DRAFT INITIAL STUDY

Foothill-De Anza College Facilities Master Plan

Re: **Notice of Preparation (NOP) of an Environmental Impact Report (EIR) and Notice of Scoping Meeting for the Foothill College Facilities Master Plan Project**

Figure 3
Foothill College Master Plan

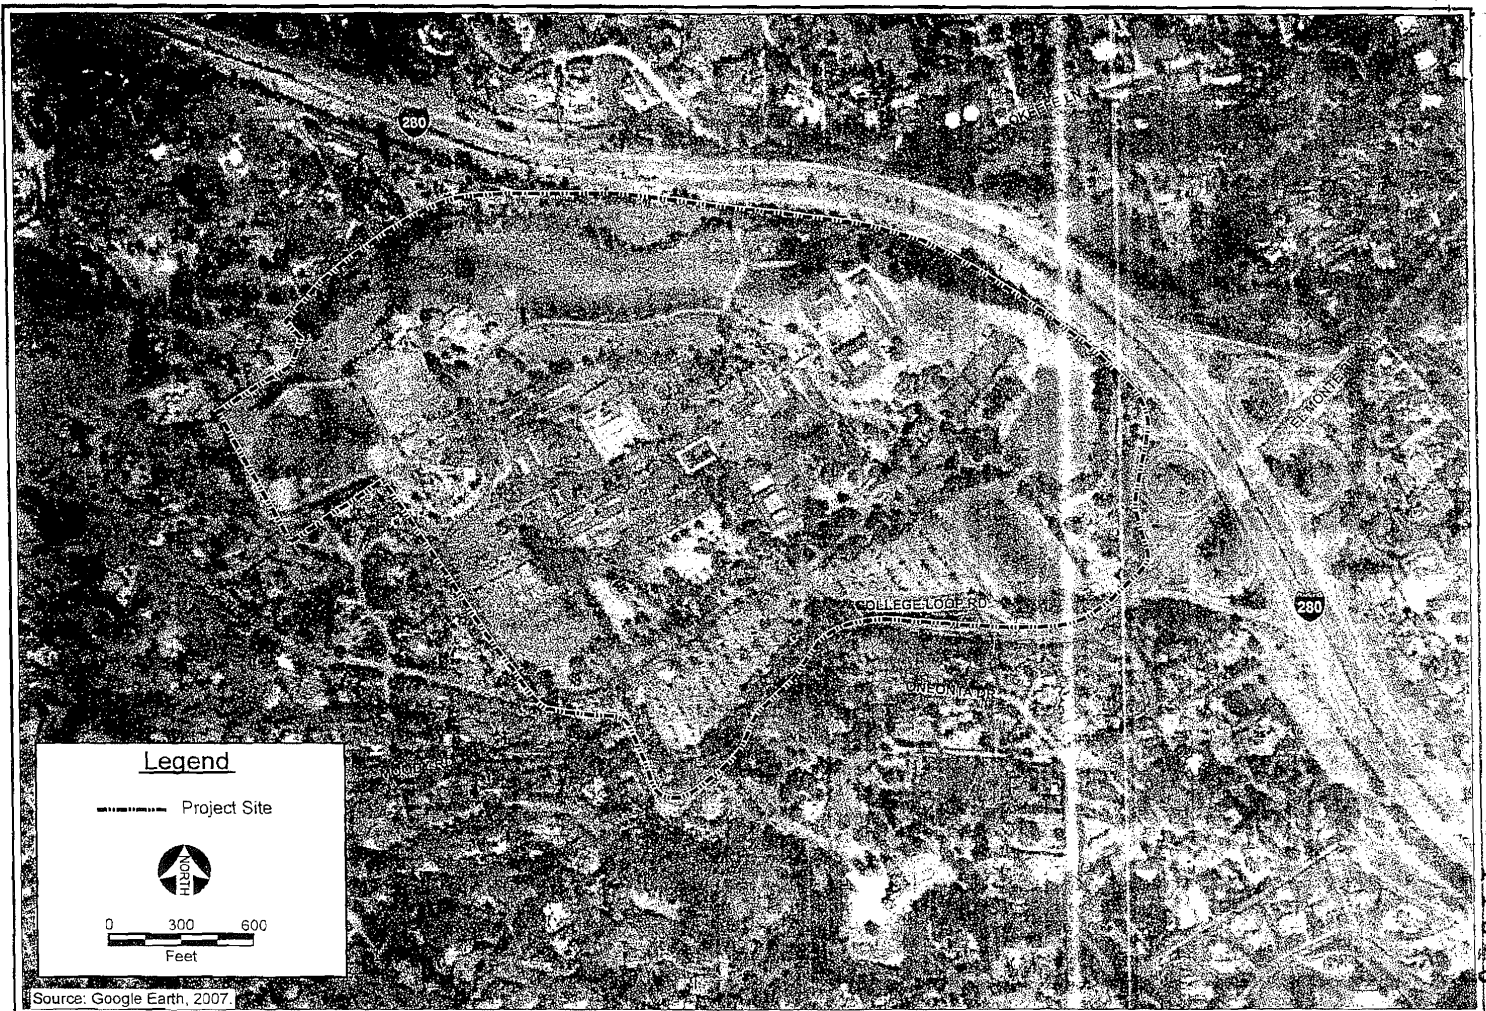
Figure 3, *Foothill College Master Plan*, indicates that implementation of the Master Plan may impact riparian vegetation along Adobe Creek or O'Keefe Creek. Any activities that may impact riparian vegetation, including any vegetation contiguous with vegetation assemblages at the top of bank, will require a permit from the California Department of Fish and Game (CDFG). In addition, if any components of implementing the Master Plan (e.g., new stormwater outfalls or bank armoring) intrude below the ordinary high water mark (OHW) in Adobe Creek or O'Keefe Creek, permits will also be required from the U.S. Army Corps of Engineers (ACOE).

We are particularly concerned regarding the greatly expanded Loop Road as shown in Figure 3 of the Foot Hill Master Plan. The routing shown which connects Lot 3 to Lot 4 will have a severe impact on our house. We will see every car which enters the campus; in the evening we will see the head and tail lights, we will hear the noise of the traffic and will get more pollution. The routing of the road will encourage higher speeds and with 400 new parking spaces, there would be more cars on the road.

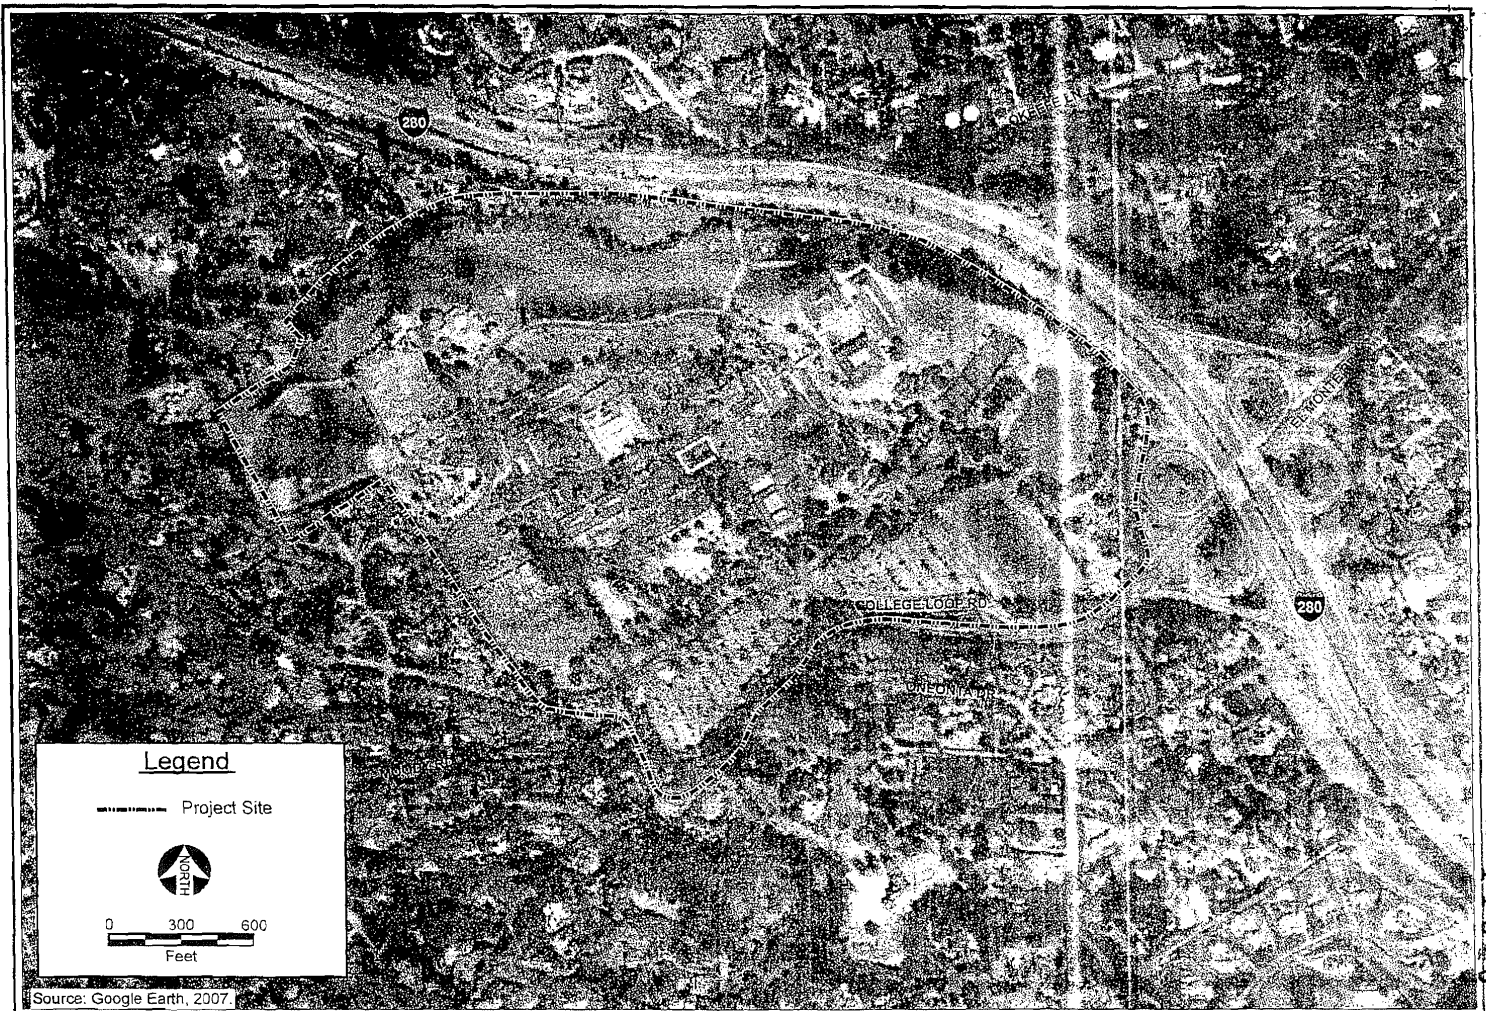
Figure 3, *Foothill College Master Plan*, indicates that implementation of the Master Plan may impact riparian vegetation along Adobe Creek or O'Keefe Creek. Any activities that may impact riparian vegetation, including any vegetation contiguous with vegetation assemblages at the top of bank, will require a permit from the California Department of Fish and Game (CDFG). In addition, if any components of implementing the Master Plan (e.g., new stormwater outfalls or bank armoring) intrude below the ordinary high water mark (OHW) in Adobe Creek or O'Keefe Creek, permits will also be required from the U.S. Army Corps of Engineers (ACOE).

We are particularly concerned regarding the greatly expanded Loop Road as shown in Figure 3 of the Foot Hill Master Plan. The routing shown which connects Lot 3 to Lot 4 will have a severe impact on our house. We will see every car which enters the campus; in the evening we will see the head and tail lights, we will hear the noise of the traffic and will get more pollution. The routing of the road will encourage higher speeds and with 400 new parking spaces, there would be more cars on the road.
